**Re: Walla Walla Solar Farm RTS Supplementary Information**

I refer to your email dated 17 April 2020 requesting further clarification on several items relating to the assessment of Walla Walla Solar Farm (SSD 9874). Responses to these items are provided in the appendices to this letter below:

Figure 1 Common residences within 1 km of both solar farms

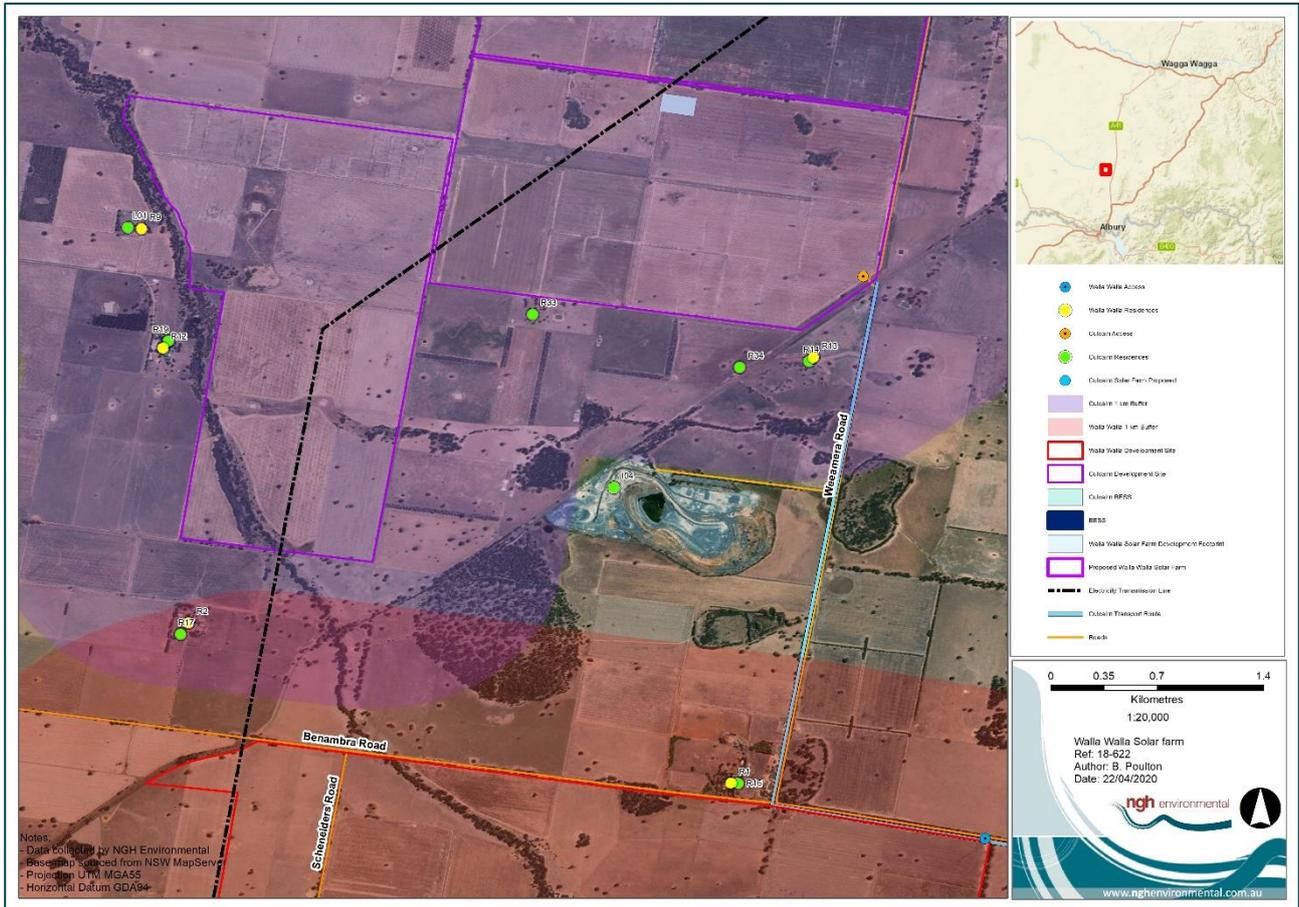
One residence (R2) shown in Figure 1 could be affected by cumulative noise impacts from both solar farms. R1a and R1b are within 500 m of infrastructure of the proposed Walla Walla Solar Farm but are located over 2 km from Culcairn Solar Farm.

An operation noise assessment was conducted to provide a worst case scenario for noise generated from the site during the operation of both solar farms simultaneously. The assessment considers residence R2 located in close proximity to the infrastructure of both proposed solar farms (Figure 1).

No exceedance above the NML is predicted to occur during the operation of the both solar farms at R2 (Table 3).
